**SIB 72 10 25****RECALL 25V-717: REPLACE BOTH REAR SAFETY BELTS**

2025-11-20

This Service Information Bulletin (Revision 1) replaces SI B72 10 25 **dated November 2025**.**What's New** (Specific text highlighted):

- Procedure/Parts – Replace the mounting hardware of the seat back side section on the affected side when removing/installing

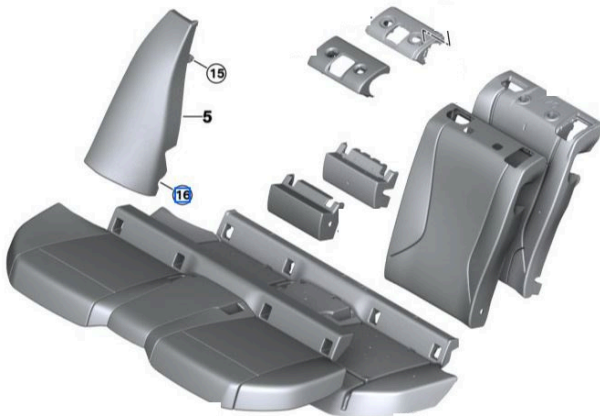
Replace the rear left safety belt (1) in accordance with repair instructions

72 11 380 (Removing and installing/replacing rear left upper seat belt).

Replace the rear right safety belt (1) in accordance with repair instructions

72 11 381 (Removing and installing/replacing rear right upper seat belt).

(F74 model shown)

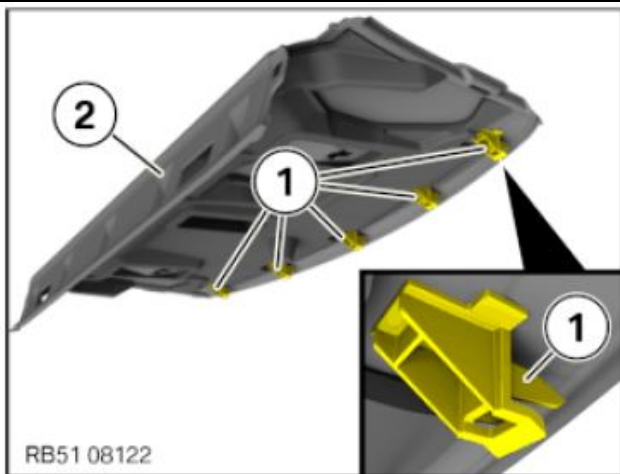
The two retainers holding the seat back side section to the body must be replaced on both sides.

- Top flat head screw 9908719 (15)
- Bottom plastic cap nut 7169847 (16)

(F74 model only)

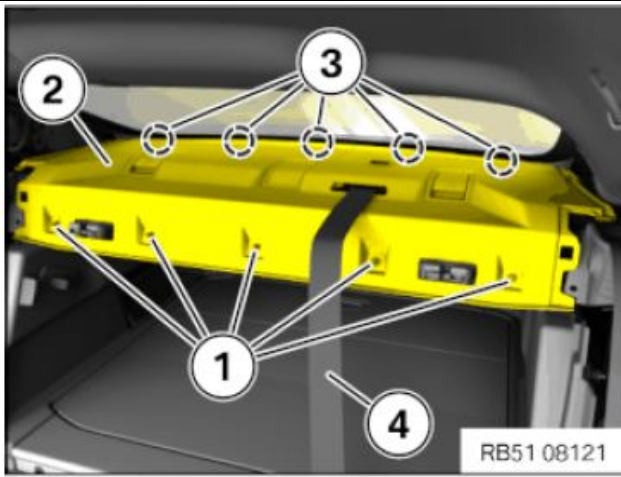
When installing the rear trim panel (F74 model) check to see if any of the snap-in lugs (1) are damaged.

The note in the Repair instruction for the rear trim panel (2) indicates to replace the trim panel **ONLY IF THE SNAP-IN LUG(S) ARE BROKEN**.

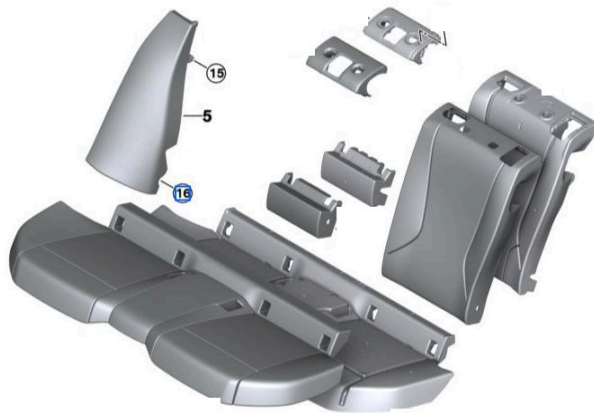
Replace the rear right safety belt (1) in accordance with repair instructions **72 11 381** (Removing and installing/replacing rear right upper seat belt).

(F74 model shown)

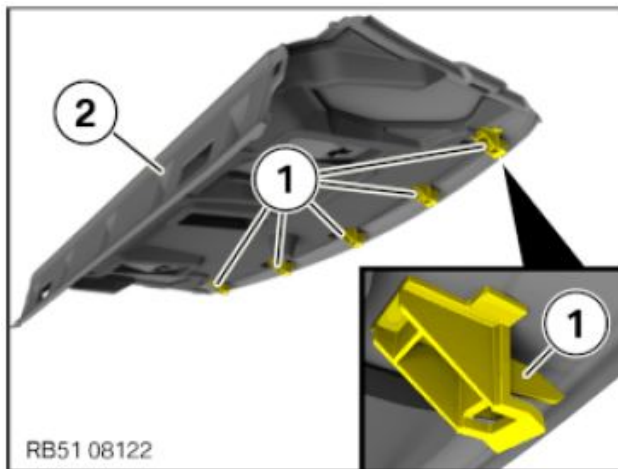
The two retainers holding the seat back side section to the body must be replaced.

- Top flat head screw 9908719 (15)
- Bottom plastic cap nut 7169847 (16)

(F74 model only)

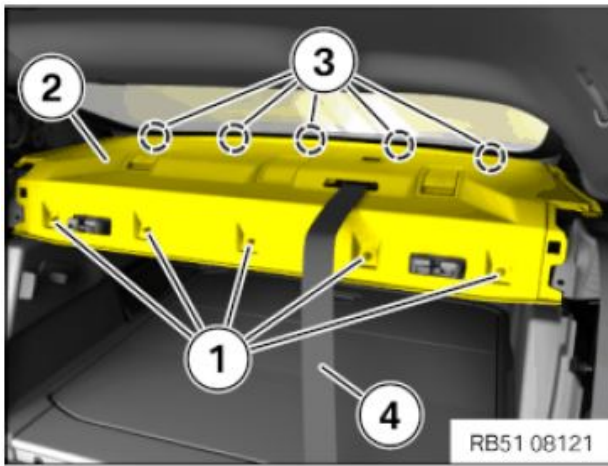
When installing the rear trim panel (F74 model) check to see if any of the snap-in lugs (1) are damaged.

The note in the Repair instruction for the rear trim panel (2) indicates to replace the trim panel **ONLY IF THE SNAP-IN LUG(S) ARE BROKEN**.

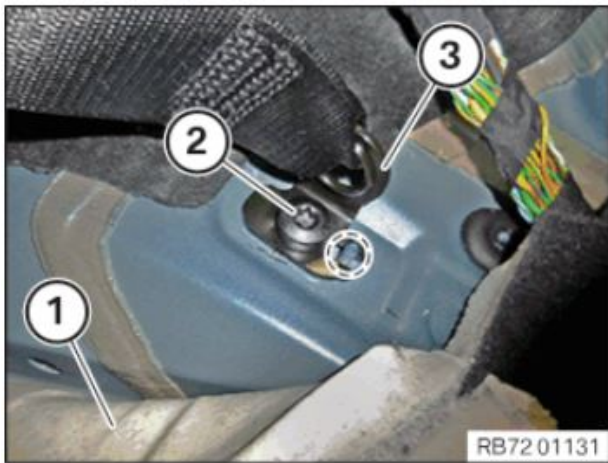
The hold down eyelets in the luggage compartment must be removed for the repair, the accompanying screws must also be reused.

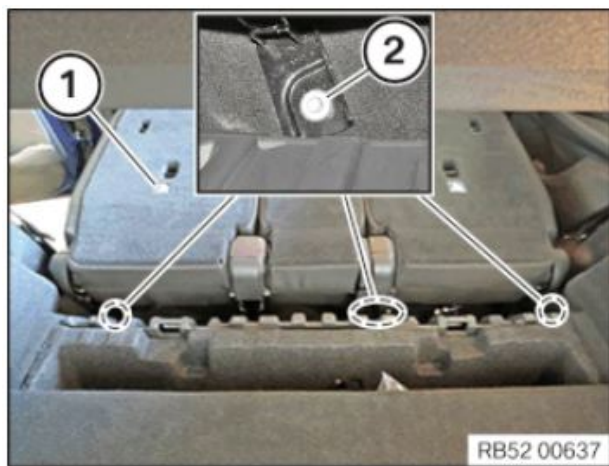
Replace the Fillister/Oval head screw (1) retaining the rear safety belt to the body (F74 model).

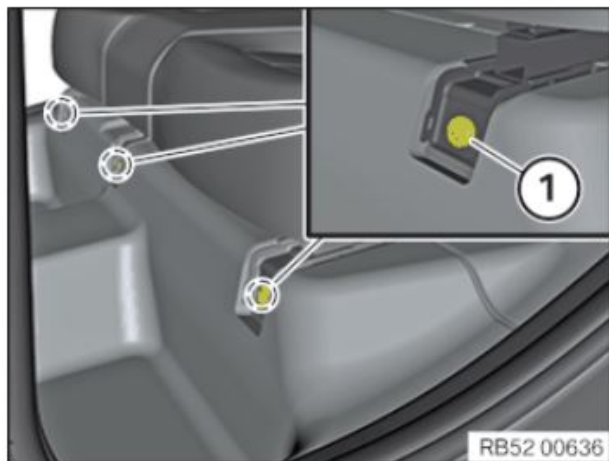
Replace the Fillister/Oval head screw (2) retaining the rear safety belt to the body (U10/U11 models).

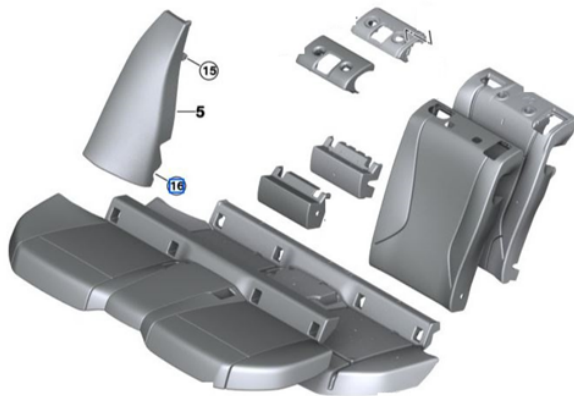
Replace the rear left safety belt (1) in accordance with repair instructions **72 11 380** (Removing and installing/replacing rear left upper seat belt).

(F74 model shown)

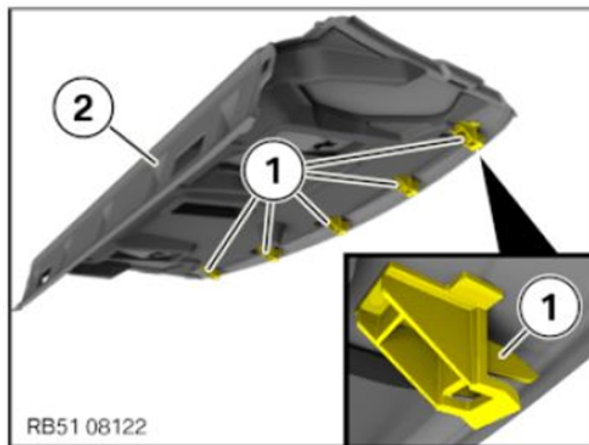
The two retainers holding the seat back side section to the body must be replaced.

- Top flat head screw 9908719 (15)
- Bottom plastic cap nut 7169847 (16)

(F74 model only)

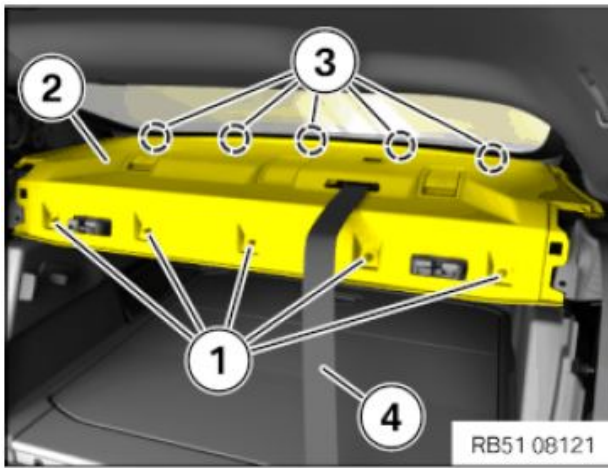
When installing the rear trim panel (F74 model) check to see if any of the snap-in lugs (1) are damaged.

The note in the Repair instruction for the rear trim panel (2) indicates to replace the trim panel **ONLY IF THE SNAP-IN LUG(S) ARE BROKEN.**

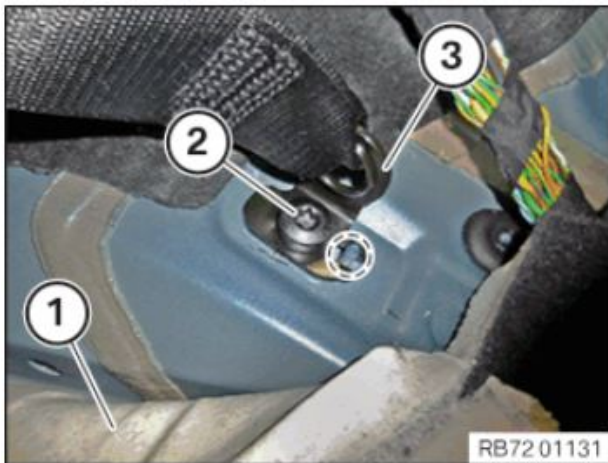
The hold down eyelets in the luggage compartment must be removed for the repair, and the accompanying screws must also be reused.

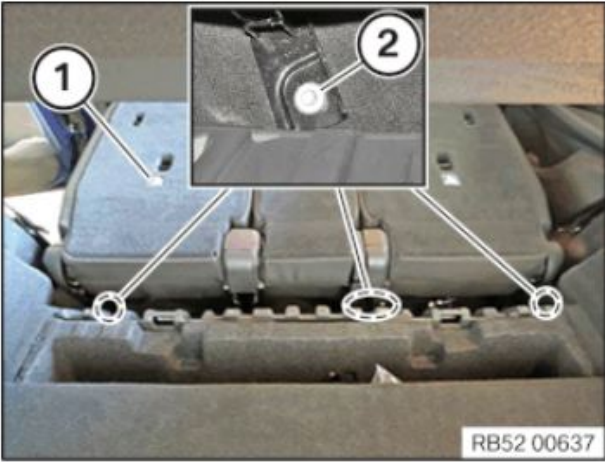
Replace the Fillister/Oval head screw (1) retaining the rear safety belt to the body (F74 model).

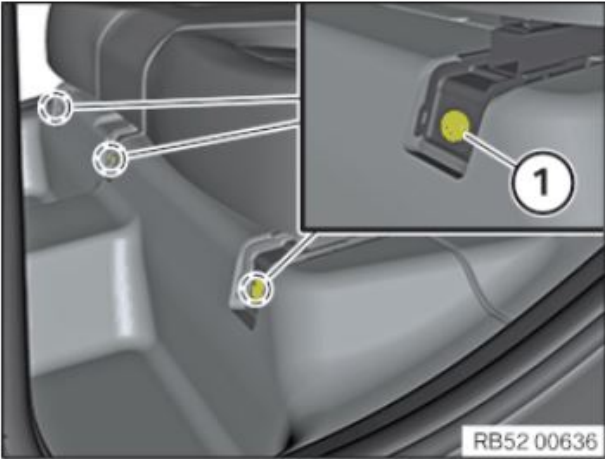
Replace the Fillister/Oval head screw (2) retaining the rear safety belt to the body (U10/U11 models).
